SAN FRANCISCO PLANNING DEPARTMENT

Certificate of Appropriateness Case Report

Filing Date: July 22, 2010
Case No.: **2010.0613AE**
Project Address: **2055 Union Street: Metro Theater (a.k.a. Metropolitan Theater)**
Historic Landmark: No. 261 – The Metro Theater
Zoning: Union Street NCD (Neighborhood Commercial District)
40-X Height and Bulk District
Block/Lot: 0541/ 018
Applicant: Stephane de Bord, Ehrman Properties
2509 Scott Street
San Francisco, CA 94115
Staff Contact Shelley Caltagirone - (415) 558-6625
shelley.caltagirone@sfgov.org
Reviewed By Tim Frye – (415) 575-6822
tim.frye@sfgov.org

The proposed project would include seismic retrofit of the 670-seat Metro Theater building and conversion of its use to a private fitness facility, restaurant, and retail use. The proposed seismic retrofit would entail the construction of a new internal steel structural frame, which would not impact the building's landmarked features. The scope of work described below describes only the aspects of the project that affect the exterior envelope of the building and are, therefore, subject to the Certificate of Appropriateness approval process per the Landmark Ordinance and Article 10 of the Pla

2C PROPOSED TENANT SIGNAGE STUDY
SCALE: N.T.S.

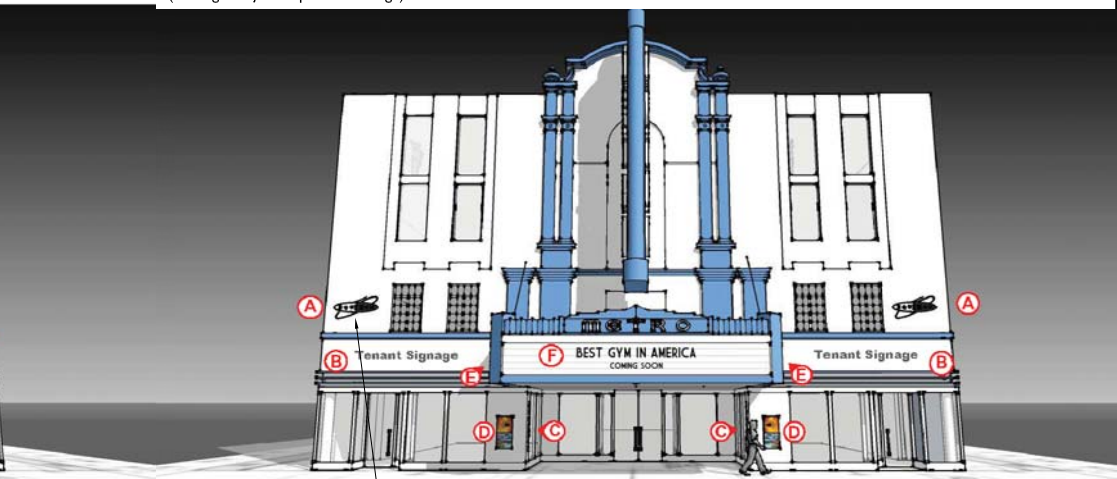
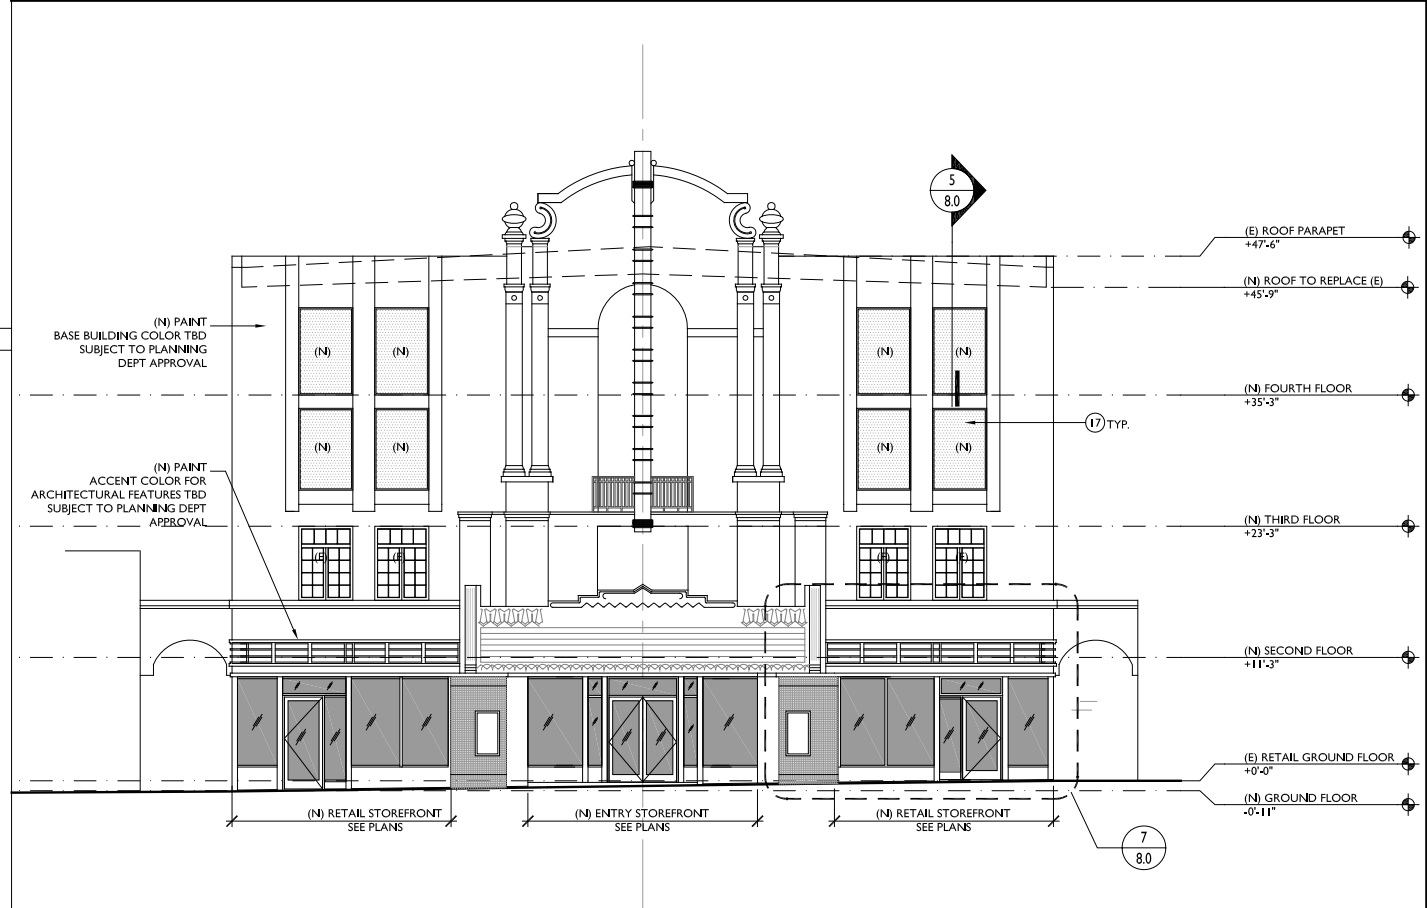
- That the two "Equinox" logo signs at the second floor level will be removed from the proposal.
- That the pattern and opacity of the fritted glass will be reviewed and approved by Planning Department preservation staff prior to the issuance of a building permits.
- That the Mitigation Measures described in the Mitigation and Monitoring and Reporting Plan (MMRP) attached as Exhibit B are necessary to avoid potential significant effects of the proposed project and have been agreed to by the Project Sponsor.

2 FRITTED GLASS AT NORTH FACADE
SCALE: NTS

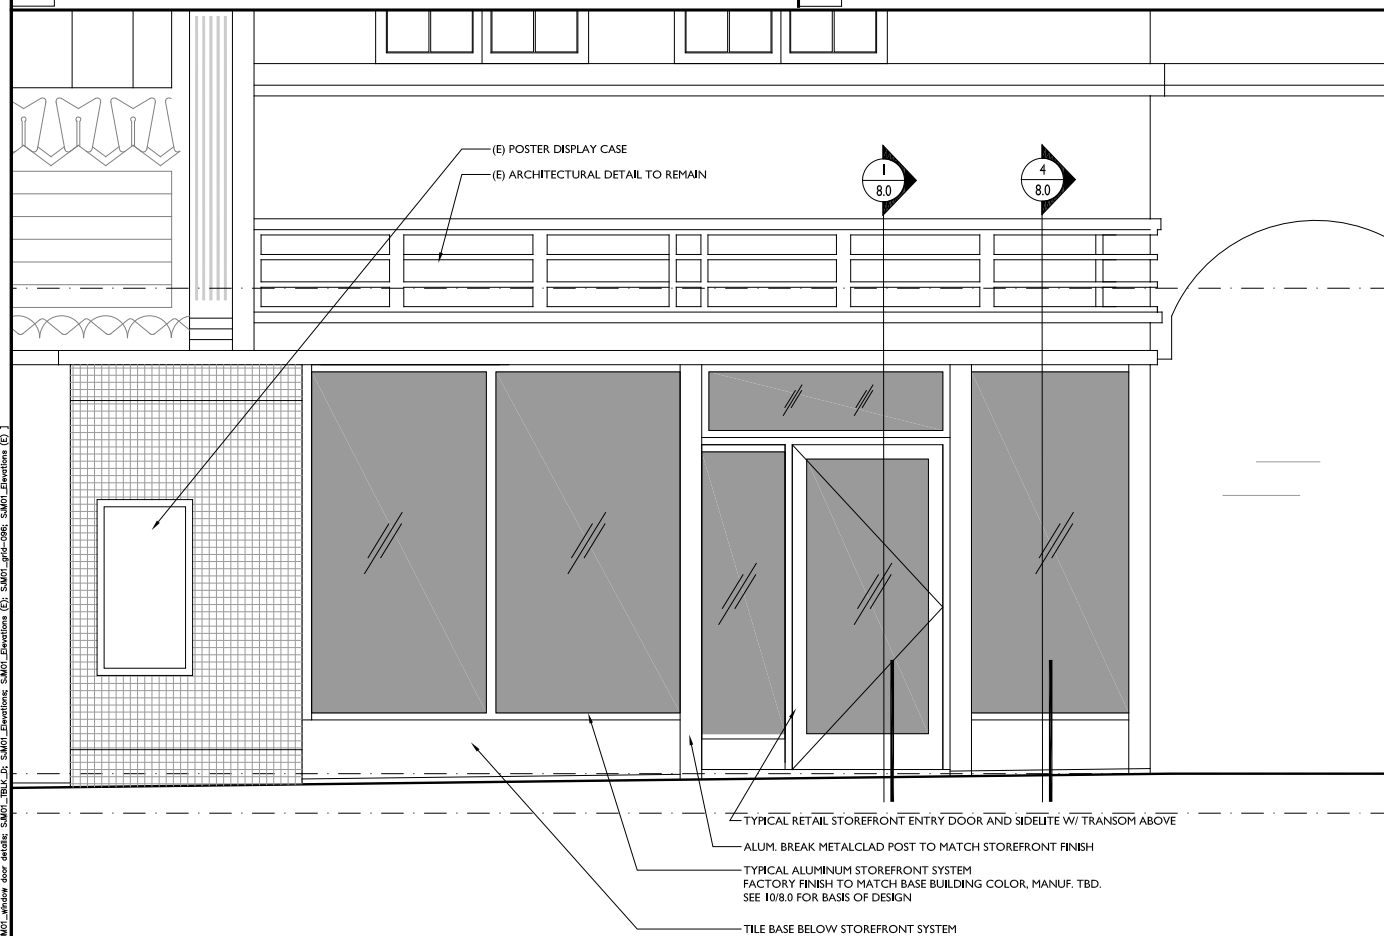
The introduction of new windows on the exterior would alter the primary façade; however the proposed punctuated openings are in character with the size, shape, and pattern of the historic windows below. Furthermore, the proposed fritted glazing would create an opacity at the window openings that lends the wall a more solid appearance. This solidity is further suggested by placing the window glazing in the same plane as the wall so that there would be no shadow line to disrupt the flat surface. Also, the new windows would be located within currently unadorned stucco panels at the front facade between the structural bays where, in the original design by the Reid Brothers, windows and ornamentation were placed (see 1924 and 1925 images on page A0.1). The introduction of windows within the panels would re-establish an element of visual interest to this area in a contemporary manner.
